Document Title: **SUBMITTAL OF RESPONSE TO THE NOTICE OF DISAPPROVAL FOR  
MATERIAL DISPOSAL AREA P SITE CLOSURE CERTIFICATION  
REPORT, LOS ALAMOS NATIONAL LABORATORY EPA ID No:  
NM0890010515, HWB-LANL-03-019**

**Response to the  
Notice of Disapproval for the Response to the Request for Supplemental Information (RSI)  
for the Material Disposal Area P Site  
Closure Certification Report, October 2003  
Los Alamos National Laboratory**

**Figure 1. Current MDA P Site conditions:  
 reclaimed, not reclaimed,  
 and undisturbed areas  
 Los Alamos, New Mexico**

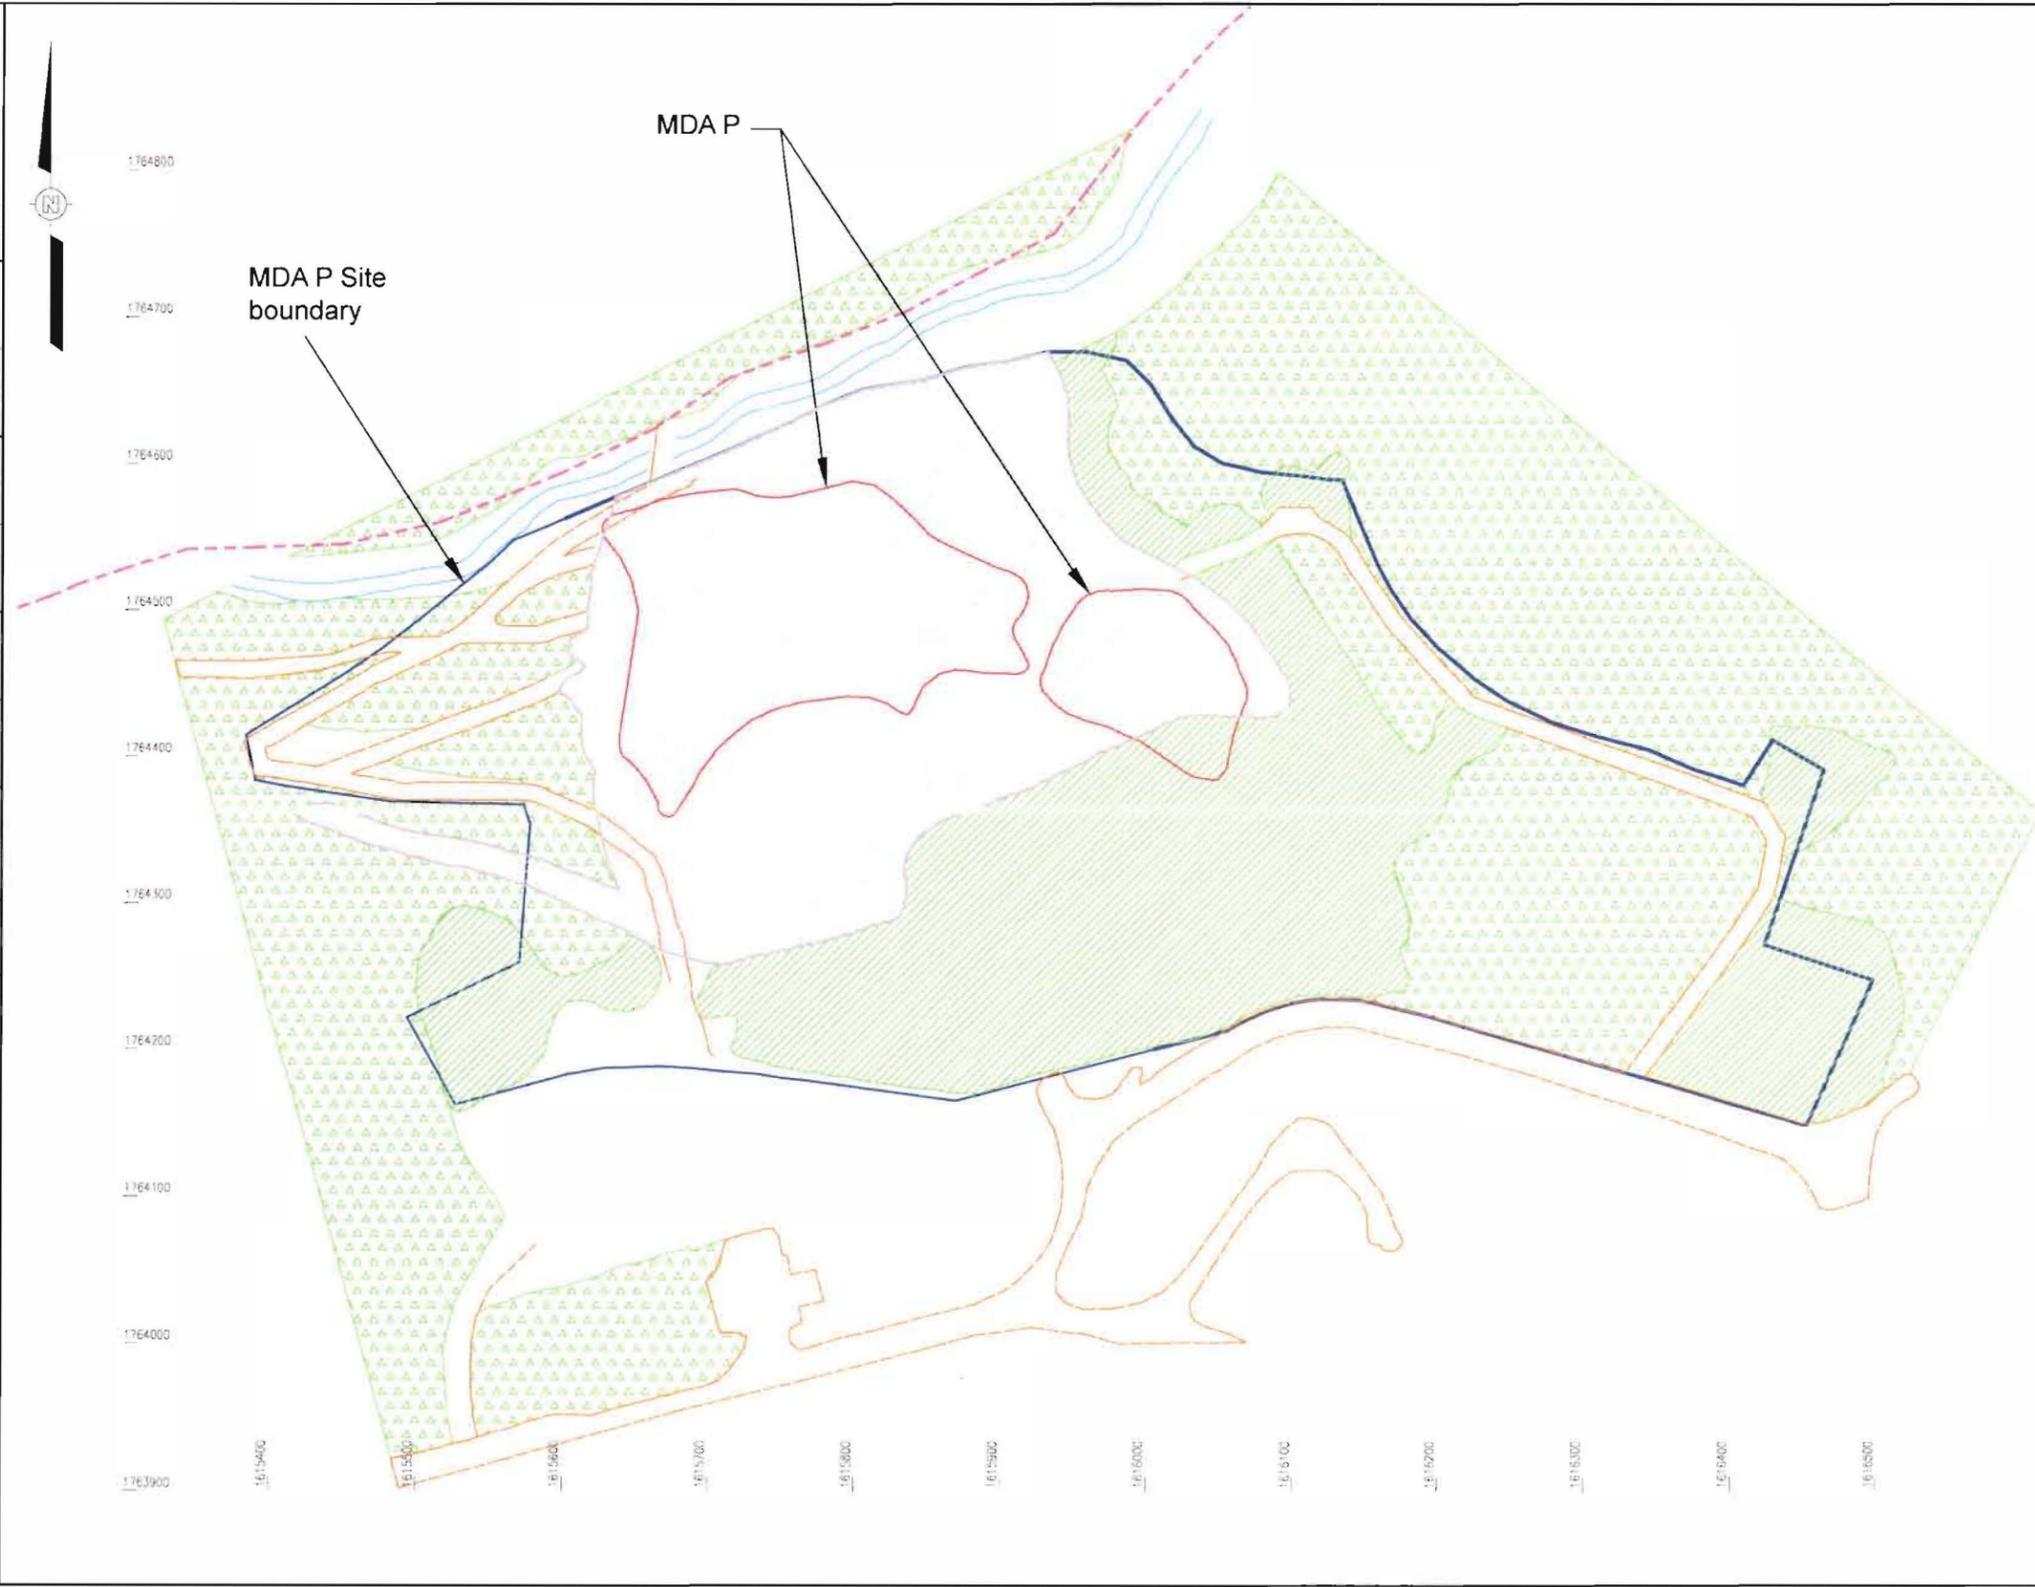
- 1. The Permittees' response to the RSI General Comment 1 is inadequate and confusing. The response contradicts itself both within bullet points and between bullet points. For example, the first bullet point, paragraph one, indicates that there are "no reclaimed areas within the Material Disposal Area (MDA) P footprint". However, the second paragraph states that "reclaimed areas exist in the biological zone" within MDA P. In addition, paragraph one indicates that topsoil at MDA P is either native topsoil or non-native soil brought in during active site operations, but that no clean fill was brought in. Paragraph two indicates that clean fill was brought in. Please revise the response to clarify the soil backfilling and reclamation activities at MDA P. It may be helpful to provide a timeline and/or figures to clarify where native soil exists, locations of operational fill (clean or contaminated), and reclaimed areas.*

There is no contradiction in the language cited. To clarify the Laboratory's response, Figure 1 of this document depicts current conditions at the MDA P Site and the surrounding area. Please note that the figure shows the boundaries of both the *MDA P Site* and *MDA P* within it—each of those terms has a specific meaning. *MDA P* refers only to that discrete hazardous waste management unit and is outlined in red on the figure. *MDA P Site* refers to the larger boundary that encompasses MDA P, as well as the other SWMUs that were combined for cleanup purposes, and is outlined in blue on the figure.

Figure 1 also shows that the MDA P Site contains both an "exposed tuff zone" (gray hatching) and a "biological zone" (green hatching and green triangles). The exposed tuff zone is comprised of bare tuff which has not been reclaimed (i.e., there has been no soil or fill material placed on it). The

biological zone is comprised of either reclaimed or undisturbed areas. The reclaimed areas contain a mix of native topsoil and operational fill (i.e., non-native soil brought in during active site operations [1950s–1984]) which has been regraded to inhibit erosion. The undisturbed areas of the biological zone contain only native topsoil.

MDA P lies almost entirely within the exposed tuff zone, except for a small portion at the southeast corner. Therefore, most of the MDA P surface is exposed tuff. Only a small portion of MDA P is covered by native topsoil and/or operational fill.

Concerning the presence of “clean fill,” no clean fill is currently present and none was present during the Phase II sampling within the MDA P Site. To clarify the RSI response, clean fill from a local commercial “borrow” source was brought in during Phase I closure activities [1996–2002], solely for the purpose of constructing staging areas within the MDA P Site. All of this fill was removed from the site at the end of Phase I closure activities in 2002 and none was sampled as part of the closure activities.
